# APPROVED MINUTES

**May 16, 2013 Standards Committee Meeting**  
**(Changes to the Final Draft by the Action of the Committee Members**  
**on 06-20-2013 meeting shown highlighted yellow)**

RE: Minutes from the May 16, 2013 Standards Committee Meeting

PROPOSED NEW 808-MLRS-01 CENTERLINE LONGITUDINAL RUMBLE STRIPE  
(SHOWN AS RPD 808-T-190d, page 1 of 3)

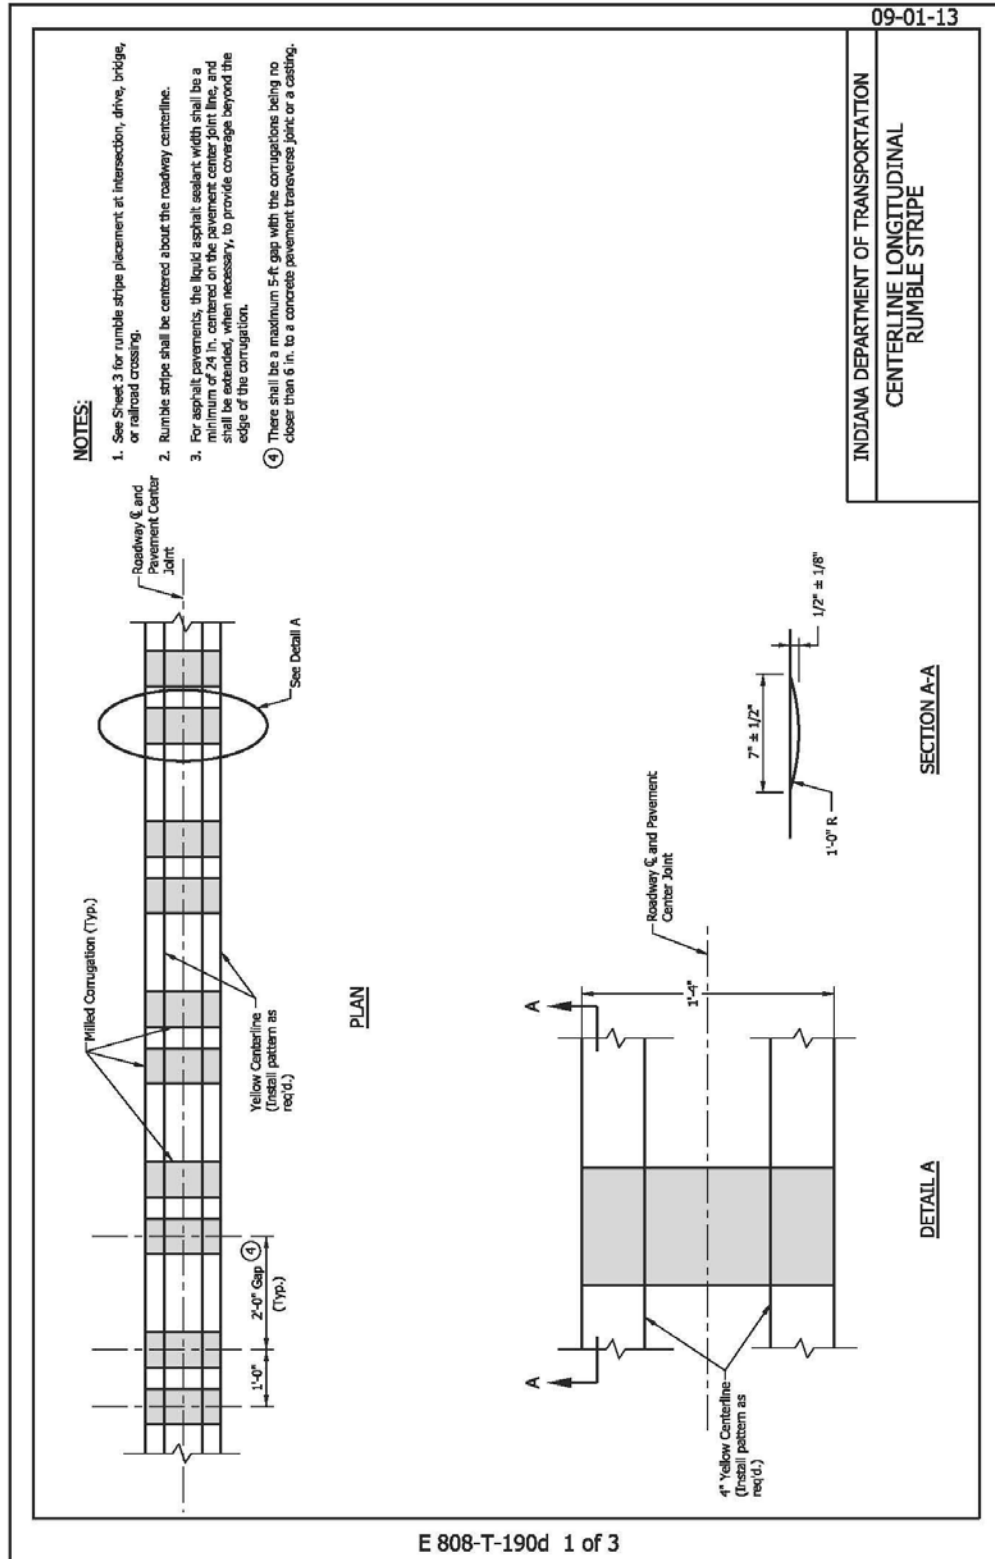
*Longitudinal rumble stripes are the combination of either the center line pavement marking placed in the center line corrugation or the edge line pavement marking placed in the edge line corrugation. They shall be installed as shown in the plans and as specified herein.*

Mr. Boruff moved that this item be approved as revised along with the revisions shown on the drawings.

EXISTING RPD 606-R-563d MILLED CENTERLINE CORRUGATIONS (PROPOSED TO DELETE)

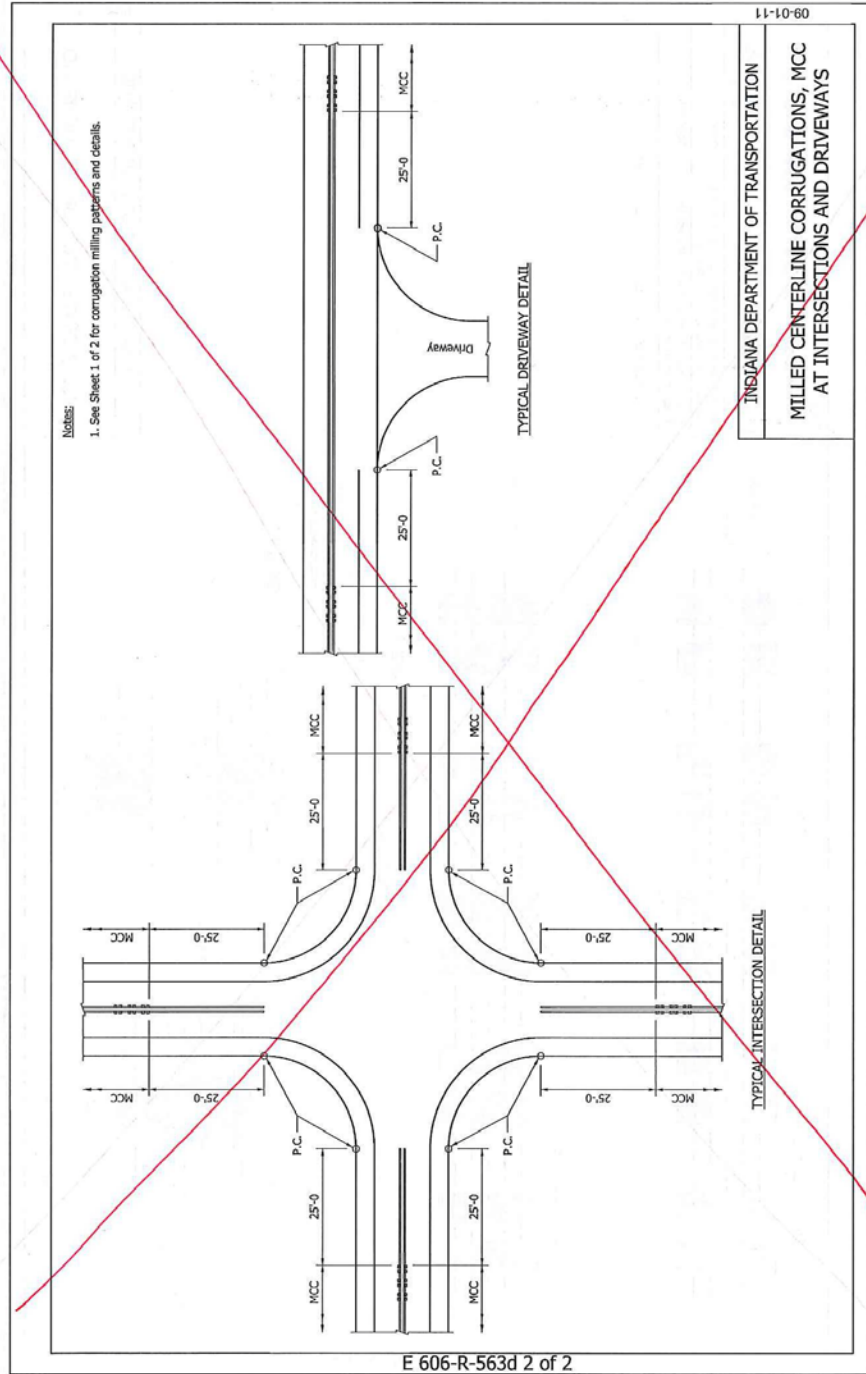
DELETE
